Access Compliance Report

Public Rights-of-Way

(Curb Ramps)

Intersection ID: 9879	Main Street: PATTON_AV	Cross Street: CREEK_ST	Location: SW
ADA ID: F70CDE9B8811	Ramp Type: Directional1	Initial Pass/Fail: Fail	Overall Compliance: No
		Severity Score: 1.25

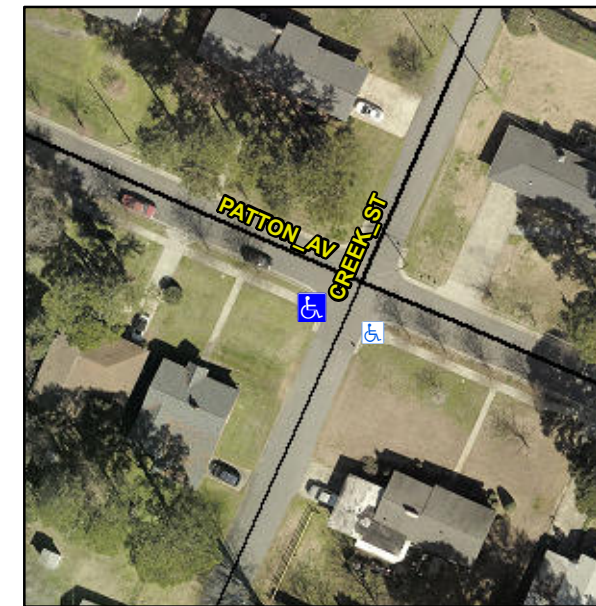
R304.5.3

Compliance	Description	Data	Compliance	Description	Data
N/A	Ramp Length (in)	366.0	N/A	Grade Break?	N/A
Yes	Ramp Width (in)	58.5	N/A	Grade Break Slope (%)	0.0
Yes	Ramp Slope (%)	7.6	N/A	Grade Break XSlope (%)	0.0
No	Ramp XSlope (%)	3.6			
N/A	Flare Type LT	N/A	N/A	Flare Type RT	N/A
N/A	Flare Slope LT (%)	N/A	N/A	Flare Slope RT (%)	0.0
N/A	Flare Traversable LT?	N/A	N/A	Flare Traversable RT?	N/A
N/A	Landing Length (in)	0.0	N/A	DWS Provided?	N/A
N/A	Landing Width (in)	0.0	N/A	DWS Contrast?	N/A
N/A	Landing Slope (%)	0.0	N/A	DWS Length (in)	N/A
N/A	Landing X Slope (%)	0.0	N/A	DWS Full Width?	N/A
N/A	Landing Curb? (Y/N)	N/A	N/A	DWS Offset LT (in)	N/A
N/A	Shared Landing?	N/A	N/A	DWS Offset RT (in)	N/A
N/A	Gutter Ponding?	0.0	N/A	Gutter Slope (%)	N/A
N/A	Gutter Lip Ht (in)	0.0	N/A	Gutter X Slope (%)	N/A
N/A	Painted X Walk1?	No		Road Slope (%)	2.4
	X Walk 1 Direction	To SE		Road X Slope (%)	0.8
	X Walk 1 Width (in)	N/A		Clear Space?	N/A

Remove & Replace Entire Ramp.
